## County of Hawai'i

### PLANNING DEPARTMENT

**SUBJECT: PLANNED UNIT DEVELOPMENT PERMIT-(PUD 07-000007)**  
**Request: PUD: HOLUALOA INN**  
**Applicant: RIEHM OWENSBY PLANNERS ARCHITECTS**  
**Owner: TURTLE BAY ENTERPRISES LLC**  
**Tax Map Key: 7-6-008:005, 008, and 030**

### Exhibit 5: Yard Designation Variance Request - Zoning Code

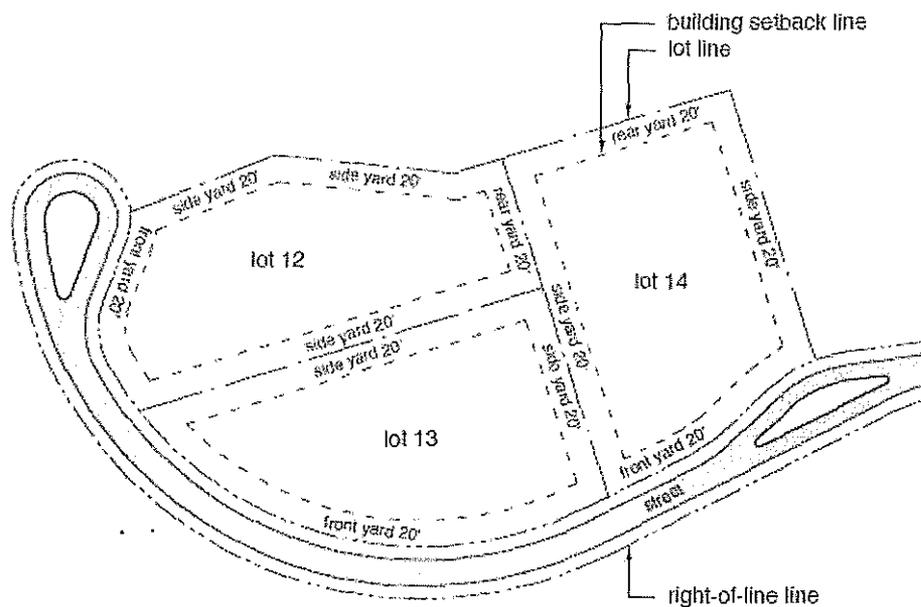
- Z-6. **Section 25-5-76. Minimum yards.** The proposed irregular shape lots and associated sizes and widths including rights-of-way are designed to create and maintain a rural image; and, preserve natural land features without resorting to excessive grading. Also, the front, side and rear yards have been designed to allow for more flexibility in locating or positioning structures in order to work better with any site grading. Refer to Exhibits and Figures attached to this PUD report for the approved configuration and application of minimum yard setbacks, which basically is limited to allowing the application of a 20-foot wide minimum front and rear yard setbacks in lieu of the required 30-foot wide front and rear yard setbacks.

proposed agricultural lots (Lots 1 thru 14) within "Holualoa Inn" in accordance with exhibits. The applicant's request for this variance to allow flexible yards for the proposed agricultural lots within the PUD or "Holualoa Inn" is approved subject also to minimum UBC-Uniform Building Code and/or the current County Building Code requirements. Refer to Exhibits and Figures attached to this PUD report for the approved configuration and application of minimum yard setbacks, which basically is limited to allowing the application of a 20-foot wide minimum front and rear yard setbacks in lieu of the required 30-foot wide front and rear yard setbacks.

### Exhibit 9: Street Lights Variance Request - Subdivision Control Code

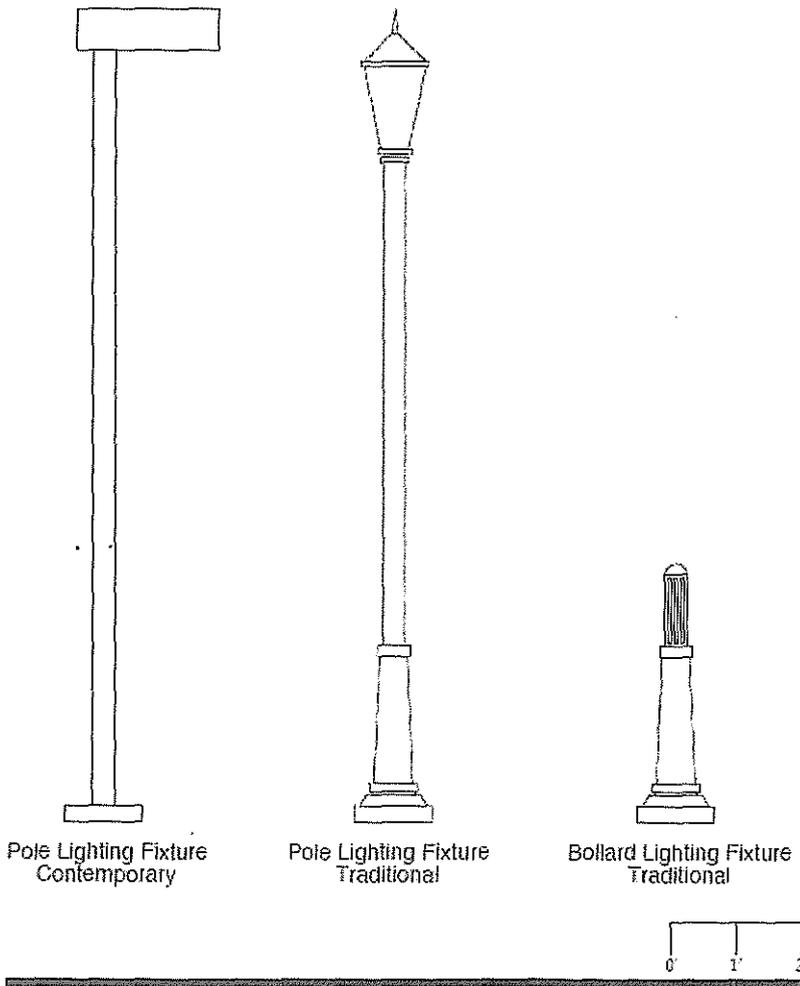
Variance Requests No.s 14 and 15 from HCC Sections 23-93 and 23-94 (sic) Any required streetlight signs and markings at the private road intersection with Mamalahoa Highway shall meet with the requirements of the Department of Public Works, Traffic Division.

- S-6. **Section 23-93. Street lights.** This variance is approved subject to provision that standard and/or alternative architectural lighting fixtures and traffic signs/names installed within the rights-of-way (road lots) and roadways including shoulder improvements being dedicated to the County are approved by the DPW and placement of architectural lighting/street names/ and traffic signs installed within the private roadways are certified by a licensed engineer for adequacy and safety. The street lights fixtures and/or lighting within proposed PUD or subdivision shall comply with Hawaii County and/or DPW outdoor lighting code requirements. These exceptions will not be permitted for any street lighting at the intersection of the private subdivision road and the Mamalahoa Highway.

Exhibit 10: Street Signs  
Variance Request - Subdivision Control Code

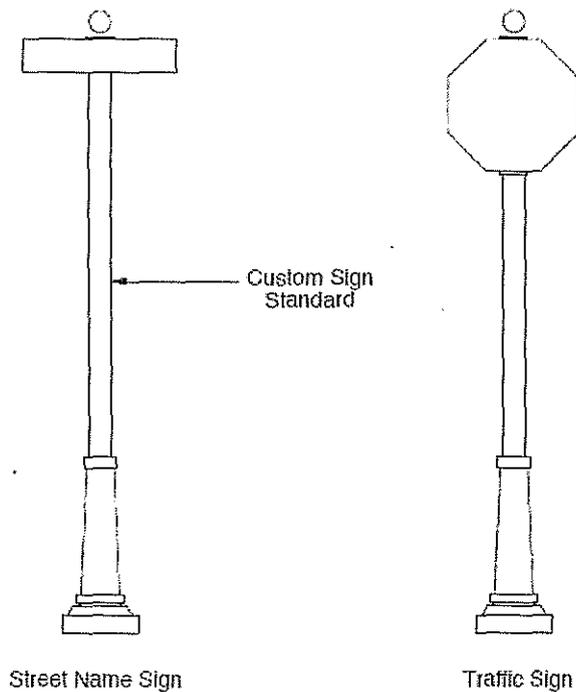
- S-7. **Section 23-94. Street names and traffic signs.** This variance is approved subject to provision that standard and/or alternative traffic signs installed within the rights-of-way (road lots) and roadways including shoulder improvements being dedicated to the County are approved by the DPW and placement of architectural lighting/street names/ and traffic signs installed within the private roadways, alleys, and pedestrian rights-of-way (trails), etc. are certified by a licensed engineer for adequacy and safety. Traffic signs

and street names shall meet minimum ASHTO specifications and standards. These exceptions will not be permitted for any street or traffic sign installed at the intersection of the private subdivision road and the Mamalahoa Highway.
